# Beechcraft SERVICE BULLETIN

No. 66-48

**SUBJECT:** TORQUING AND SAFETYING THE FUEL STRAINER (GAS-KOLATOR) RETAINING BOLT

**AIRCRAFT AFFECTED:** All BEECHCRAFT Model 23, A23 and A23A Musketeers, prior to M-976; all Model A23-19 Musketeer Sport III's, serials MB-1 through MB-119; all Model A23-24 Musketeer Super III's, serials MA-1 through MA-93.

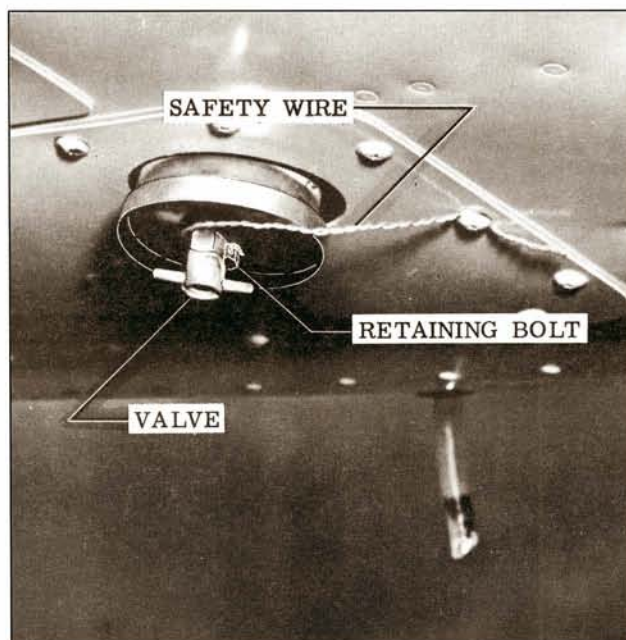
**DESCRIPTION:** Owners of the BEECHCRAFT Musketeers noted above should be sure that the retaining bolt in the fuel strainer is installed with the proper bolt torque, 25 inch-pounds, as stamped on the strainer.

The retaining bolt must also be safetied to the fuselage (rather than, for example, to the strainer valve), as shown in the accompanying photograph.
